Subject: Revision of mounting profile 120mm for trapezoidal roofs (7269120)

In this product update, we want to inform you about an upcoming revision to the mounting profiles L=120mm (7269120) for placing panels in landscape orientation on trapezoidal roofs.

Revision: 4 holes instead of 2

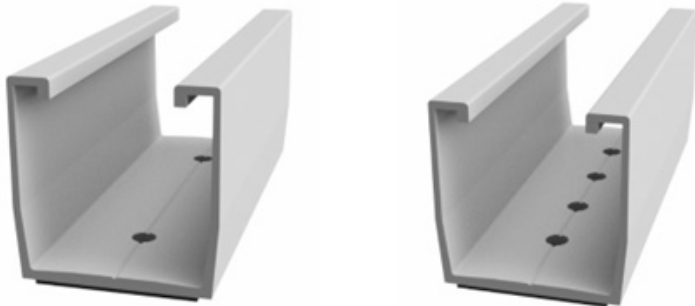
Until now the 120mm trapezoidal profiles for landscape orientation of the PV-panels have 2 holes to fix the profile to the roof, using either thin sheet screws or rivets. With this revision, the number of holes will be increased from 2 to 4. This will enable the option to fix the profiles with more screws / rivets for higher strength per profile. This can be required for regions with high wind loads and panels placed in the edge zone.

Current version with 2 mounting holes

New version with 4 mounting holes

In standard situations, only 2 of the mounting holes need to be used for fixation. Whenever more screws per profile are required, this will be indicated automatically in the project report generated by the ValkPVplanner. Additional screws/rivets will then be added to the BOM.
